To: Planning Commission

From: Public Member Crystal Chaix (neighbor)

Subject: Questions, comments and concerns regarding Agenda item 4 on the November 12, 2025, Planning Commission Meeting

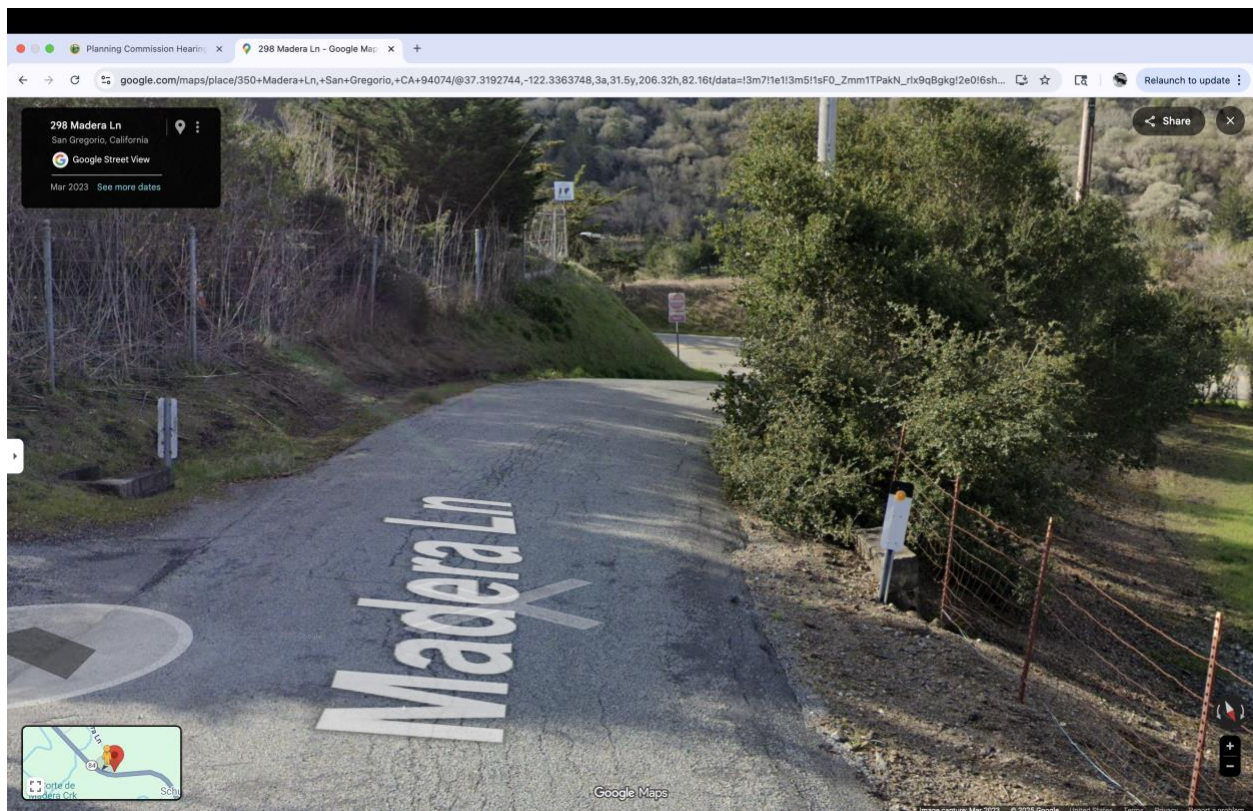
Under Discussion- A. Key issues, 3. (2.d.)

The productivity of any adjacent agricultural lands is not diminished, including the ability of the land to sustain dry farming or animal grazing.

“the parcel to the west contains residential use associated with an onsite agricultural operation.”

“The productivity of these adjacent agricultural lands is not expected to be impacted by the proposed project.”

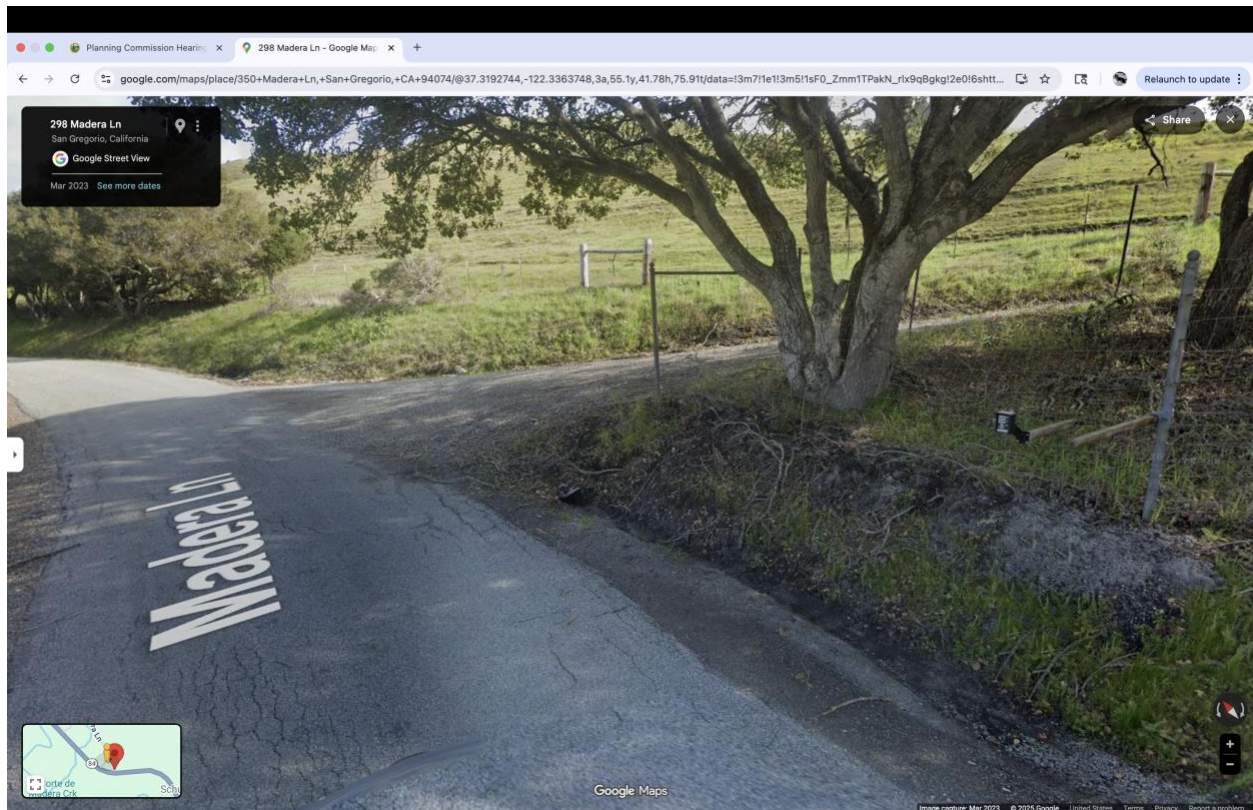
Looking at the photo below, you will see that the runoff flows west down the applicant’s driveway and into the ditch. The ditch has a concrete culvert that runs under Madera Lane with the outlet flowing into my crop of hay.

On the other side of the driveway, there is a culvert that runs along Madera Lane to the west. It too flows into a culvert and flows into the Corde Madera Creek.
